Product hierarchy no. *				Part no.	SBU	Product Type	Customer part no.
SBU	PG	PUG	Type				
03	070	029	0000003459	See list below	Switches	TTS

- Removal of the CE mark on the TTS

Product Change Notification					PCN TTS - CE sign removal from products		
owner	creation date	release date	released by	change order no	rev	page	D10-066-264
riedlan	13.07.2022	28.07.2022	riedlan	2024260	B	1 of 1

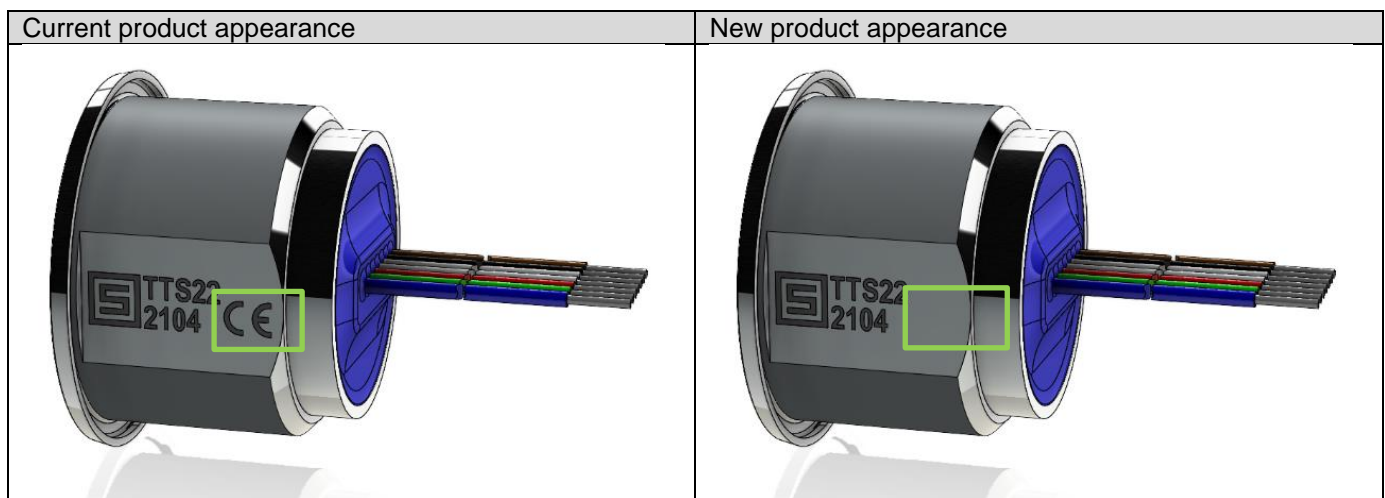
- Change of labelling on the product

- Improved legibility of the product marking

The change takes effect in ww 39/2022 (Date code 2239 or higher on label)
